Proposed Housing Development
in Farrankelly, Co. Wicklow

Stage 1 Road Safety Audit

Document Ref: P18-067-RP-001

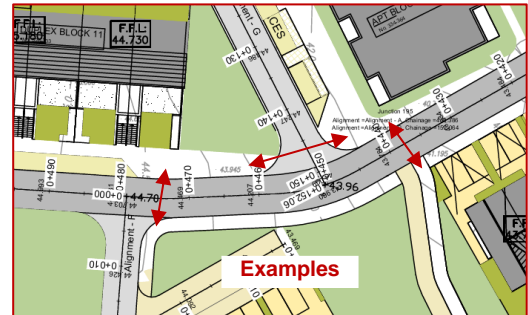
Summary: Unclear if there is sufficient drainage provision within the proposed development.

It is unclear at this early stage in the design process if sufficient drainage provision has been provided within the development. Should inadequate drainage measures be provided, this could lead to ponding on the footpath or carriageway resulting in slips and trips during wet or icy weather.

Ensure that the footpath and carriageway is adequately drained.

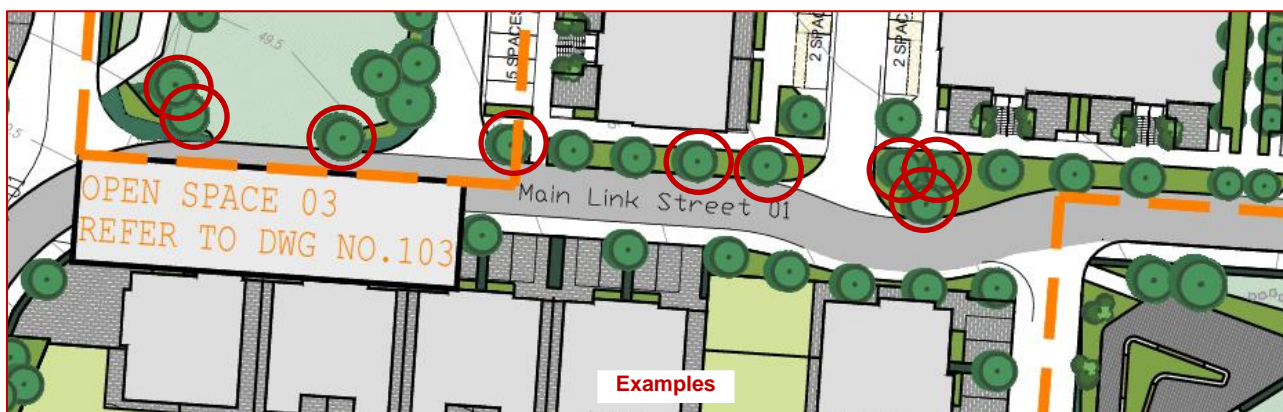
Summary: Information regarding signage/roadmarkings not provided to the Audit Team.

Information regarding the proposed signage/roadmarkings within the development has not been provided to the Audit Team. The Audit Team are aware that this is a Stage 1 Road Safety Audit and that this information is likely to be considered as the design progresses. However, if sufficient consideration is not given to the various sign types, their size and location, this could result in signs being insufficiently visible to drivers. This could result in drivers being insufficiently aware of the road layout leading to driver confusion and an increased risk of collisions.

Ensure all necessary signs and roadmarkings are provided during the detailed design stage and that the signage is of sufficient size, and located, such that it is sufficiently visible to drivers.

Examples: Main Link Street 01 junctions with Local Streets 10 and 12

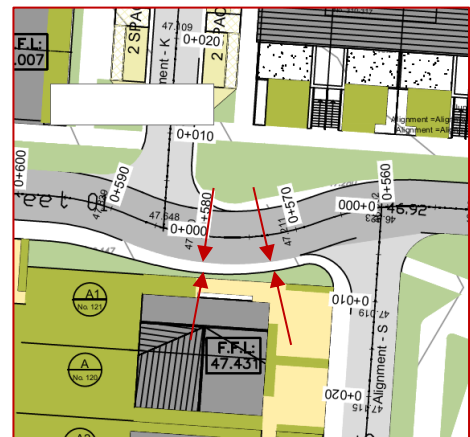
Summary: Visibility exiting side roads could be restricted by trees within the footpath.

Trees have been indicated within the footpath adjacent side road junctions throughout the scheme. These trees could restrict a driver's visibility towards approaching vehicles when stationary at the junction. This could result in drivers entering the carriageway ahead of oncoming vehicles when it is unsafe to do so leading to side-on collisions.

Ensure the trees within the scheme do not impede a driver's visibility when exiting side roads. The trees should be relocated if necessary.

Location: Local Street 12 junction with Local Street 13

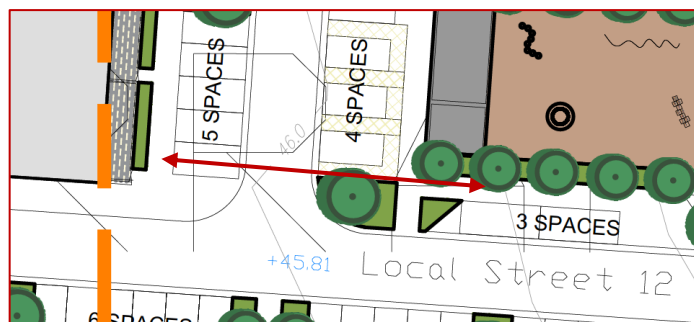
Summary: Mobility parking provision appears to obstruct or restrict pedestrian movement across the side road.

Mobility parking spaces are provided at the junction of Local Street 12/Local Street 13. However, the mobility parking spaces appear to block pedestrians from continuing along Local Street 12. This may force pedestrians into the carriageway, where there is an increased risk of being struck by a vehicle.

Pedestrians should have unobstructed access across the side road junction, allowing them to safely continue their journey through the development.

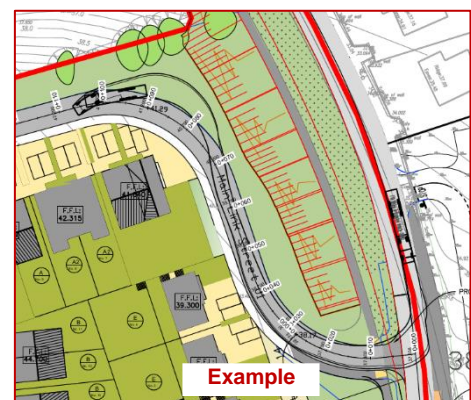
Summary: The pedestrian footway switches from one side of the road to the other, though no pedestrian crossing has been provided to facilitate pedestrians crossing from one footway to the other.

The pedestrian footway on Main Link Street 01 terminates at various locations within the development, with pedestrians required to cross the road to join the footway on the other side, allowing them to continue their journey through the development. However, no pedestrian crossings have been provided at these locations, which may make it difficult for visually impaired and mobility impaired pedestrians to cross the road. This could lead to mobility impaired pedestrians having to continue along the carriageway until a dropped kerb is provided, which may increase the risk of vehicle/pedestrian collisions. Visually impaired pedestrians may be unable to independently cross the road where a crossing is not provided, leading to slips, trips and falls as they step up or down from the kerb.

Ensure pedestrian crossing facilities are provided along desire lines, particularly where pedestrians need to cross the road to continue their journey through the development.

Similarly, crossings should be provided where pedestrians access amenities, such as Public Open Space or playground facilities.

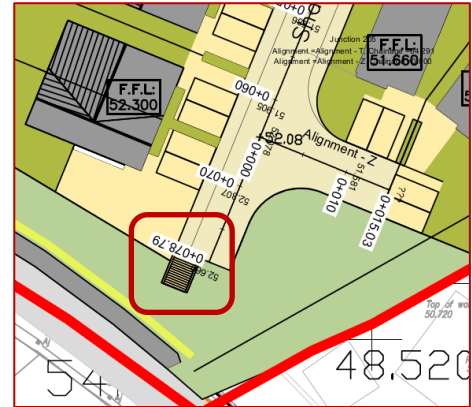
Summary: It is unclear if there is sufficient swept path for vehicles within the development.

It is unclear if the proposed layout can accommodate the swept path of large vehicles at each junction within the development (i.e. buses using the active open space facility, refuse truck, etc.). If insufficient space is provided this may lead to vehicles mounting the inside kerb when undertaking turning manoeuvres, thus increasing the risk of vehicles striking pedestrians.

Swept path analysis should be undertaken to ensure sufficient turning space is provided for vehicles within the development, and where horizontal radii is less than outlined in DMURS.
